## Access Compliance Report Public Rights-of-Way (Curb Ramps)

Intersection ID: 10020275 Main Street: AYRSLEY\_TOWN\_BV Cross Street: N/A Location: N

ADA ID: 5970B46CADE0 Ramp Type: Perp Initial Pass/Fail: Fail Overall Compliance: No Severity Score: 12.5

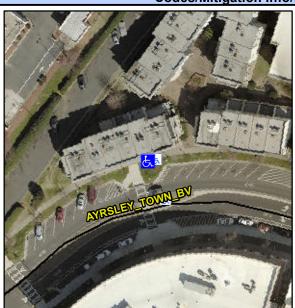
NOT Found, R304.5.3

Field Measurements/Component Compliance						
Compliance Description		Data	Compliance		Description	Data
N/A	Ramp Length (in)	116.0	Yes	Ram	Slope (%)	7.7
Yes	Ramp Width (in)	80.0	No	Ram	XSlope (%)	6.7
N/A	Flare Type LT	N/A	N/A	Flare Type RT		N/A
N/A	Flare Slope LT (%)	N/A	N/A	Flare	Slope RT (%)	N/A
N/A	Flare Traversable LT?	N/A	N/A	Flare	Traversable RT?	N/A
N/A	Landing Length (in)	N/A	N/A	DWS	Provided?	N/A
N/A	Landing Width (in)	N/A	N/A	DWS	Contrast?	N/A
N/A	Landing Slope (%)	N/A	N/A	DWS	Length (in)	N/A
N/A	Landing X Slope (%)	N/A	N/A	DWS	Full Width?	N/A
N/A	Landing Curb? (Y/N)	N/A	N/A	DWS	Offset (in)	N/A
N/A	Shared Landing?	N/A				
N/A	Gutter Ponding?	N/A	N/A	Gutte	r Slope (%)	N/A
N/A	Gutter Lip Ht (in)	N/A	N/A	Gutte	r X Slope (%)	N/A
N/A	Painted X Walk1?	No	N/A	Paint	ed X Walk2?	N/A
	X Walk 1 Direction	To SW		X Wa	lk 2 Direction	N/A
N/A	X Walk 1 Width (in)	N/A	N/A	X Wa	lk 2 Width (in)	N/A
	X Walk 1 Slope (%)	0.1		X Wa	lk 2 Slope (%)	N/A

Remove & Replace Entire Ramp.
